HISTORIC LANDMARK COMMISSION STAFF REPORT

Wright Addition & New Garage 1204 East First Avenue Avenues Historic District PLNHLC2012-00139 June 7, 2012

Planning Division
Department of Community
and Economic Development

SOUTH
Elevation

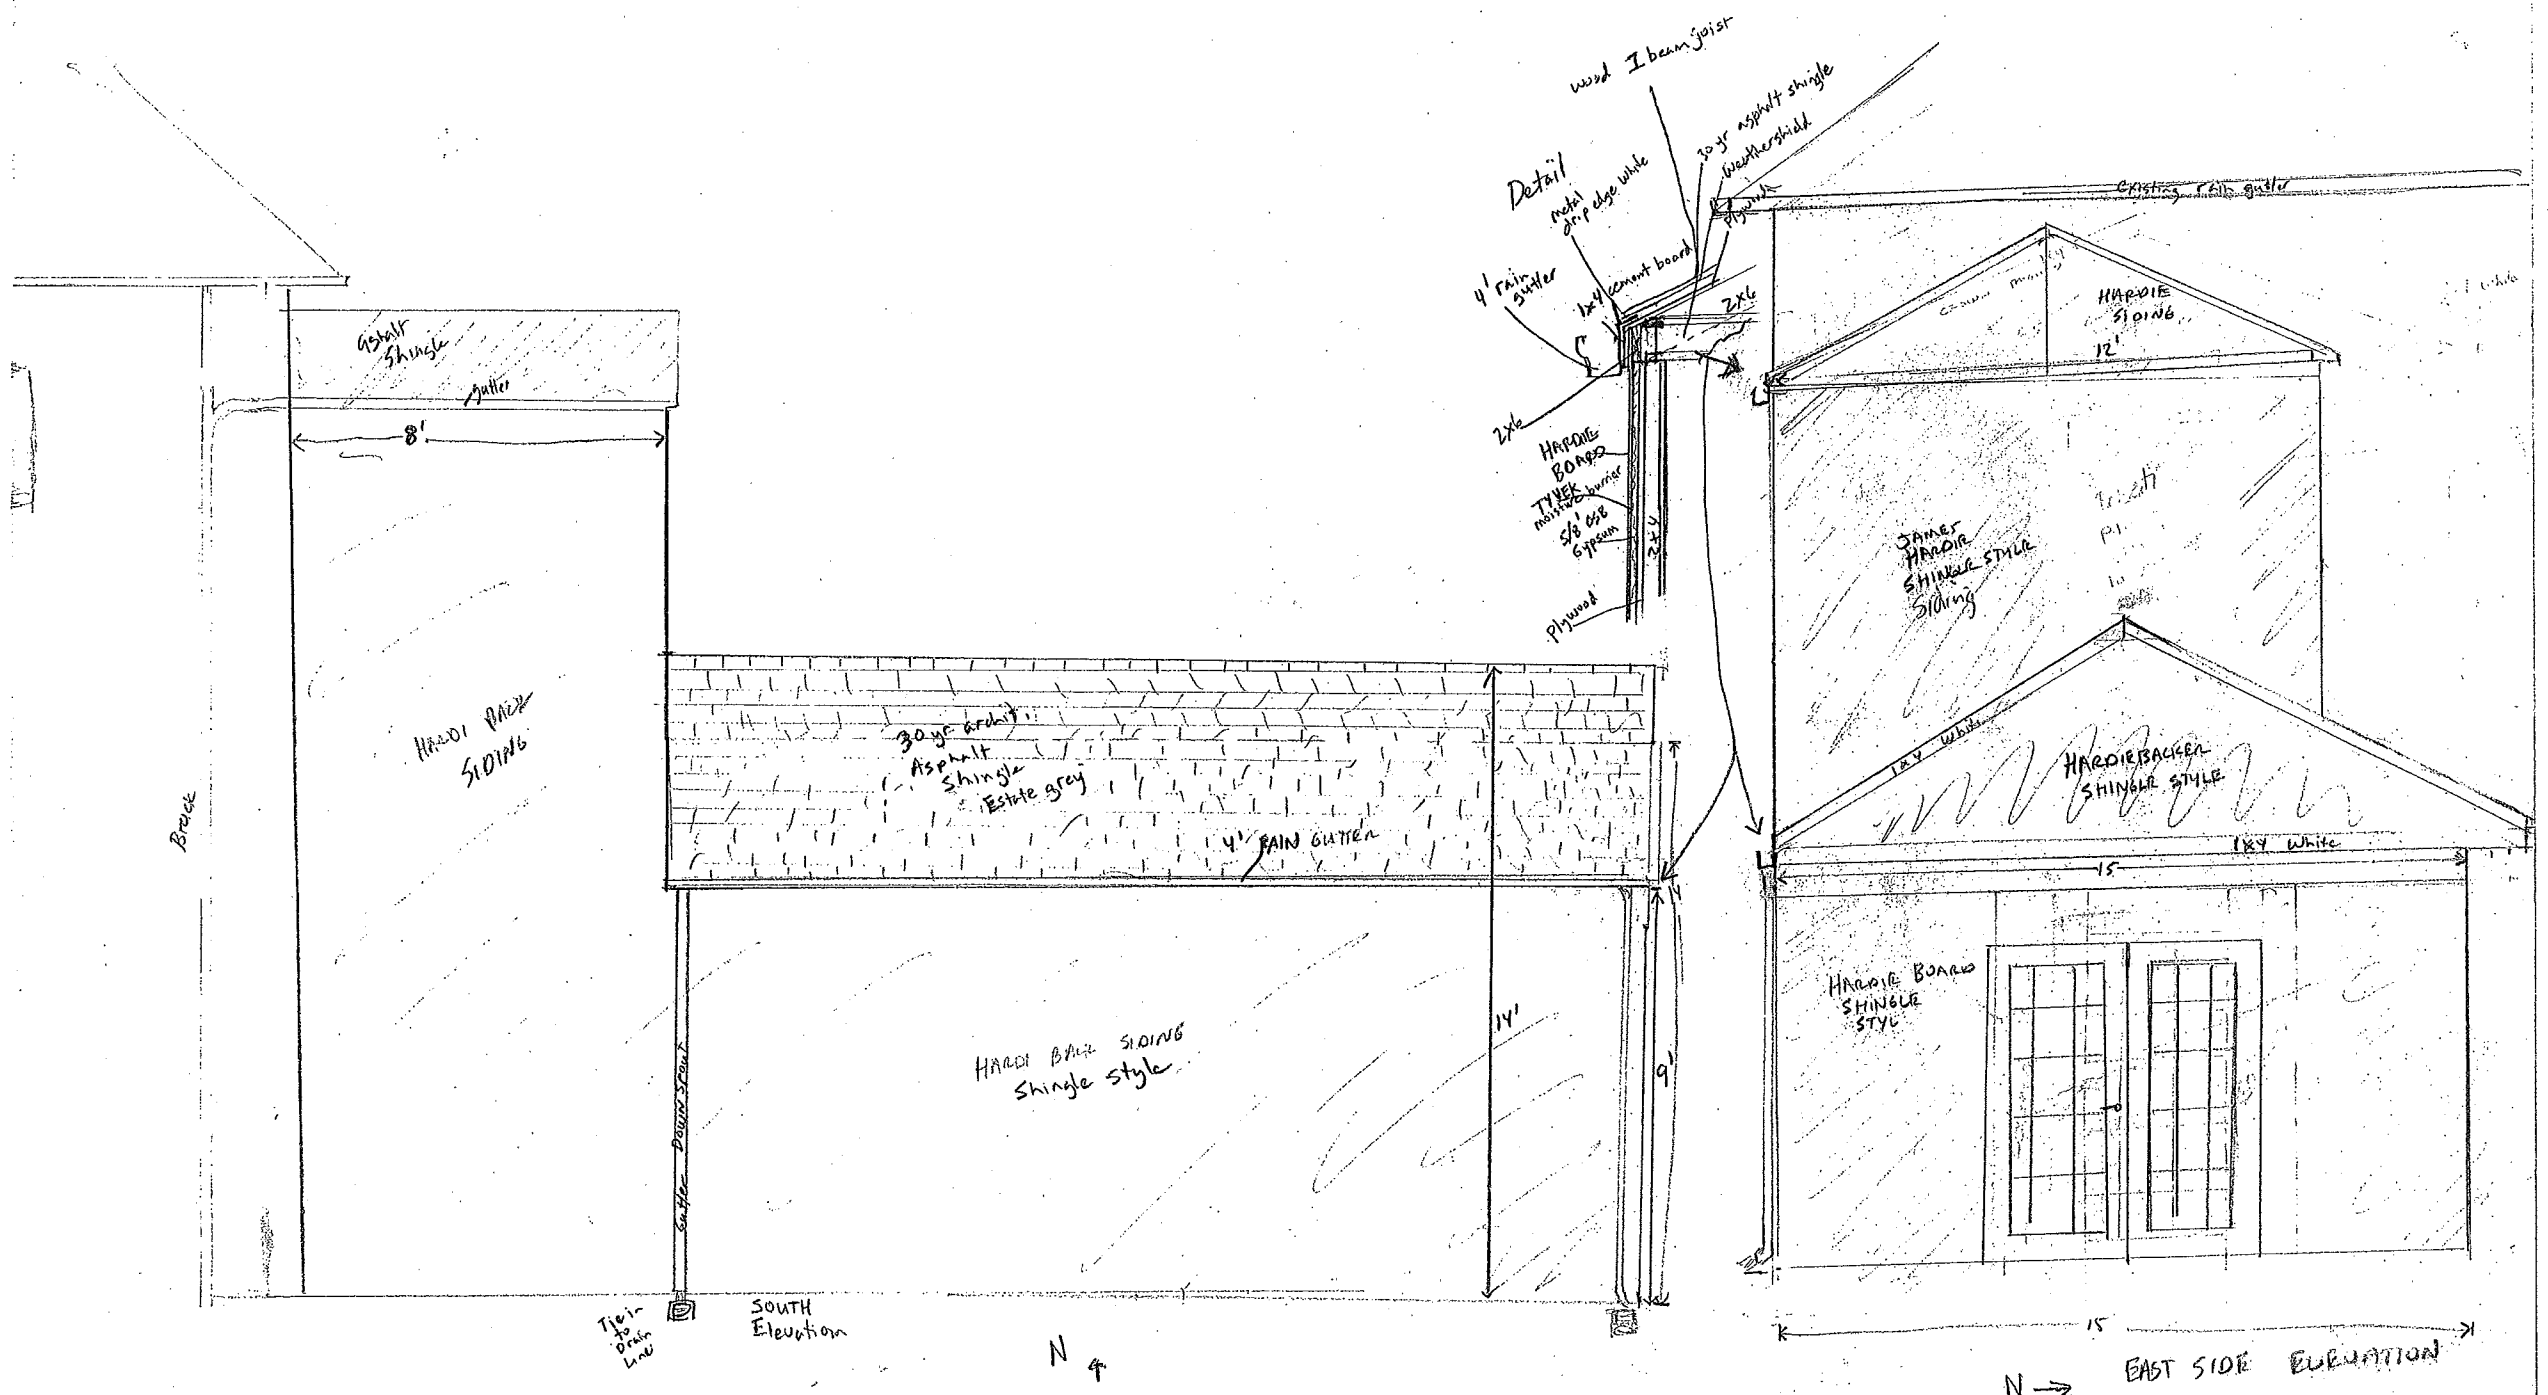
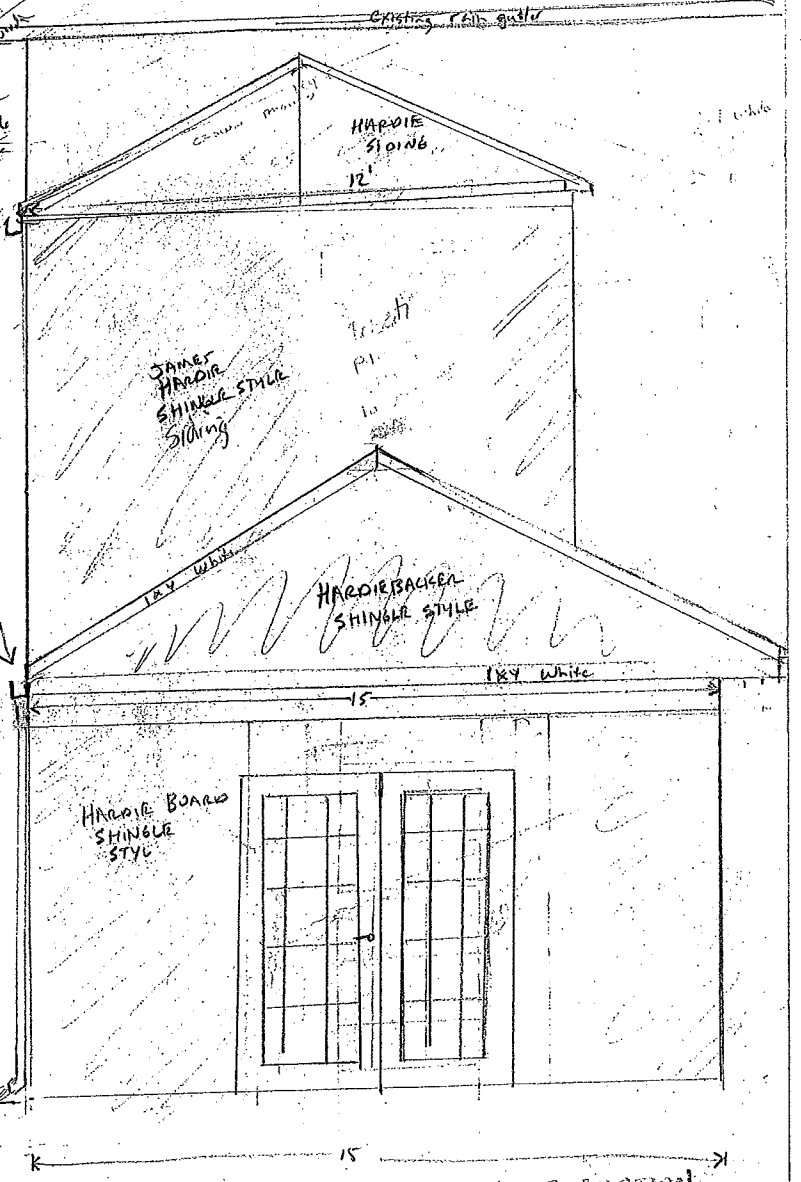
Two issues: (1) the drawings / plans posted to the web show the crest of the garage and the crest of the eastward addition of the main house. The notes say both are 16 ft above grade. But the drawings show the garage crest at a higher elevation than the addition. The new owners have removed the parking pad and have deposited considerable fill from the excavated basement east of 1204 including across the old parking pad. **Please enforce that the base for the garage not be higher than that of pre-site base.** My fear is that the new garage will be constructed on a foundation higher in elevation than the parking pad, and therefore be a more massive structure, and a more light- and neighbor-blocking structure because it “begins” on recent fill. And... the old grade took water south and west from the site but an elevated foundation could dam the natural egress. (Again, the new owners intend to capture all drainage and send it across their property to exit on U Street.)

As for the shape of the garage: indeed the surface area of its roof is larger than that of the garage of the 1900s. We appreciate how the southern half of the garage roof will drain south as per Merrick Wright's plans. We also appreciate that the new plans show the crest of the roofs of the addition and the proposed garage as 14 ft above land surface. Both those factors seem "good" for the neighborhood feel. Please review what is meant by "land surface." The land surface along the south of the lot has been raised above original grade. Will the concrete pad of the new garage be significantly higher than that of the original grade / the surface of the concrete pad of the 1900s garage? The topography slopes west and south. Defining what 14 ft above grade really means may take some clarification.

East Elevation
Entryway to be
partially removed

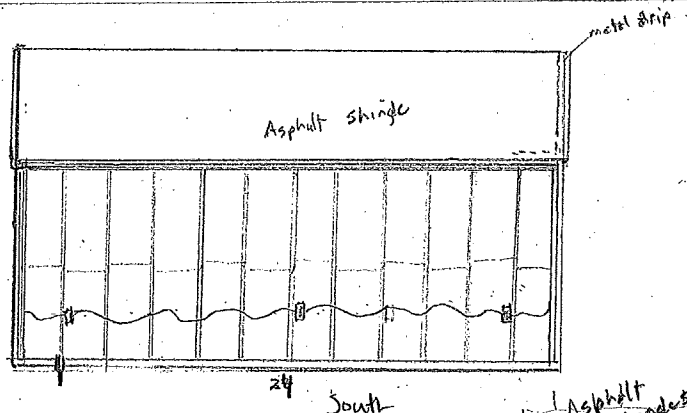
Analysis: The applicant is proposing to remove portion of the entryway on the east elevation. The entryway has a crescent shape with four steps on each side with decorated iron railings. Although the entryway was probably not original to the house it has been there since before 1936. This entryway is an architecturally significant element of the house that is visible from the street.

Finding: Staff finds that this project does not comply with this standard and that the entryway is a significant architectural element that will be partially destroyed. In order to retain this architectural element, the area between the home and the sunroom 8 feet wide and 12 feet deep, could be inset even further to accommodate the entire entryway. Consequently, the second story addition, an extension of a walk-in closet, would have to be eliminated.

According to plans before you, the inviting, rather handsome, east entrance of 1204 First Ave will be chopped back to allow for the sun room addition. Of course the neighborhood feel will change. Some may find the "upgrade to be more like Federal Heights" an improvement to our Lower Avenues style. I kind of like the Lower Avenues low-key charm.

**Attachment D
Department Review**

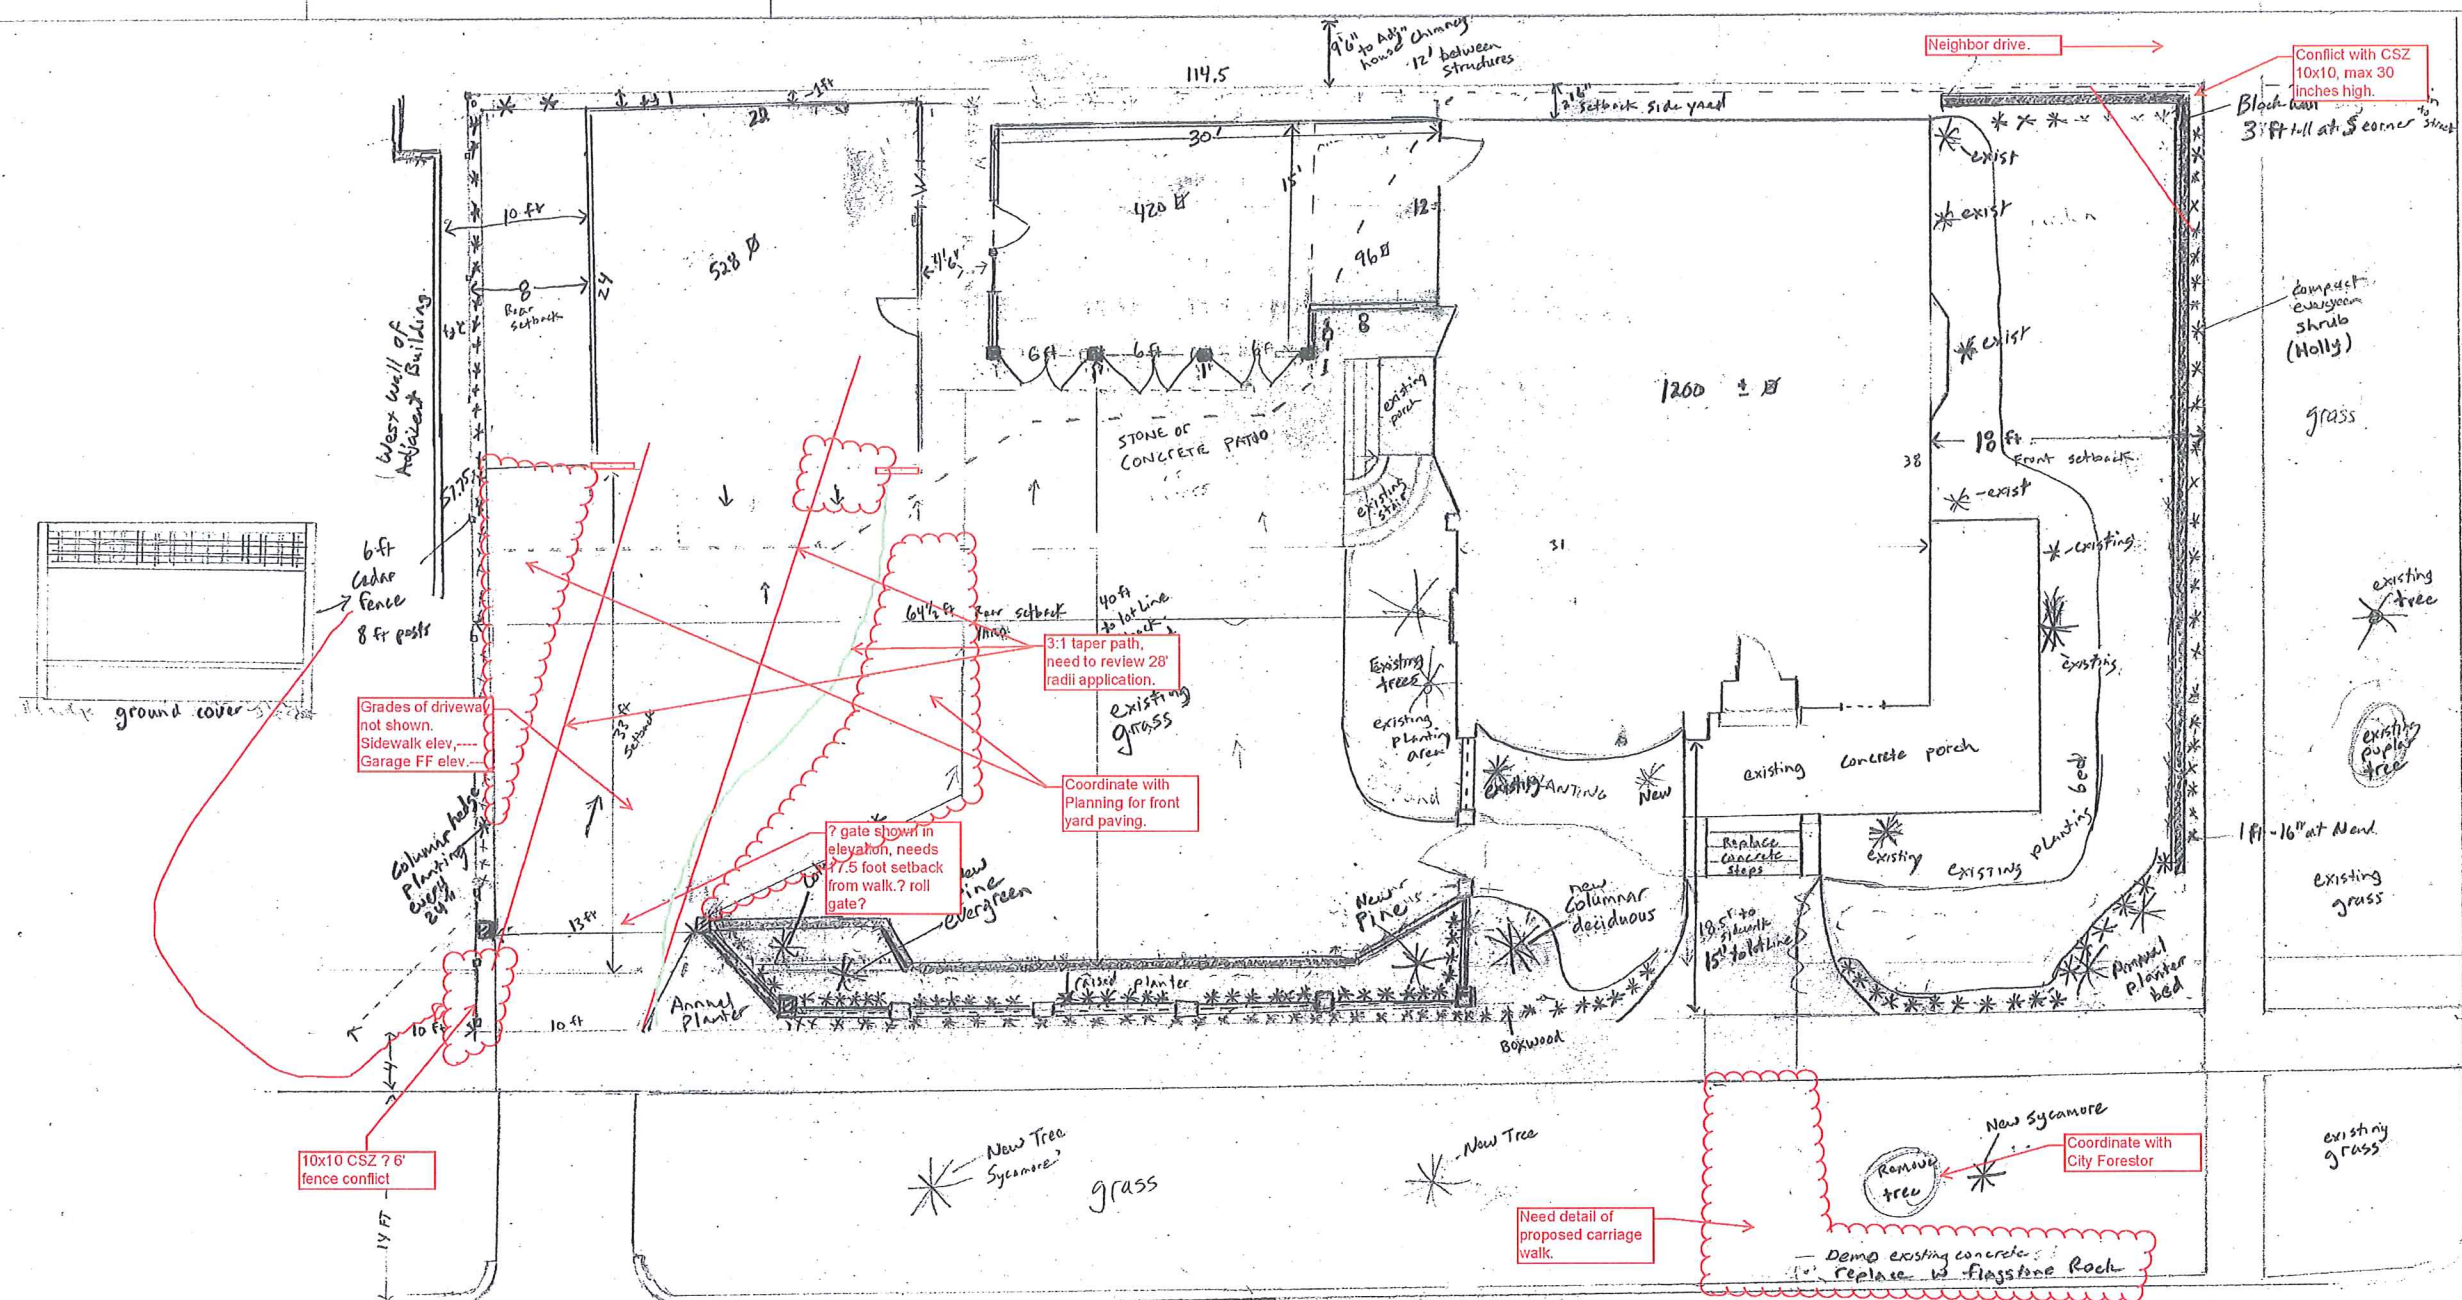
Clear sight zone abutting the driveway for this lot and the lot to the south are in conflict with the 6' cedar fence and the 3' high block wall.

The driveway indicates excess paving to be reviewed by Planning for front yard parking. The 3;1 taper and the 28 foot turning radii vehicle access path is shown on the mark up PDF.

There are no elevations or grades shown for review of the driveway proposal, for slope transitions and staging.

The carriage walk needs to be detailed in compliance with city standards.
